**Reference: Responses to Request for Additional Information (Group 2) on the Application for Amendment of USNRC Source Material License SUA-1475 for the United Nuclear Corporation Mill Site, McKinley County, New Mexico (2<sup>nd</sup> submittal)**

**Responses to USNRC Comments (Group 2) on the Application for Amendment of USNRC Source Material License SUA-1475 for the United Nuclear Corporation Mill Site (2<sup>nd</sup> submittal)**

## Request for Additional Information – Group 2 Safety Evaluation Report

**Figure 4.3-3a:** Upstream and Downstream Cross-Section Locations

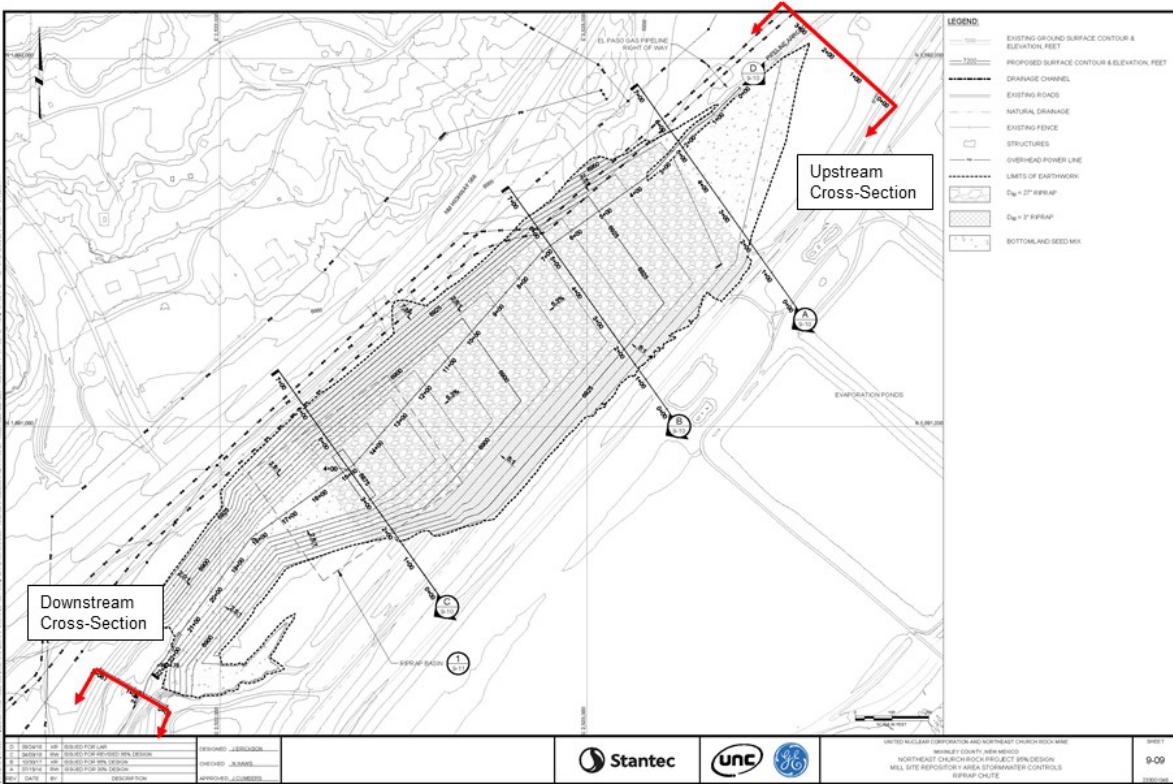
Please provide a sediment transport calculation to justify the sediment transport in the design channel of the Pipeline Arroyo between the upstream and downstream of the sunken basin limit to be in a natural balance regime. Please provide information to demonstrate that the design of the downstream channel at the sunken basin outlet can convey the sediment without a sediment deposition to migrate the channel alignment.

*Stantec evaluated the sediment transport capacity upstream and downstream of the riprap chute and basin using the same methods and equations in Attachment I.4 of Appendix I, where the flow depth and shear stress are calculated based on the Manning's Equation for the 5-year and 10-year design discharges. The upstream and downstream sections evaluated are shown in Figure 4.3-3a.*
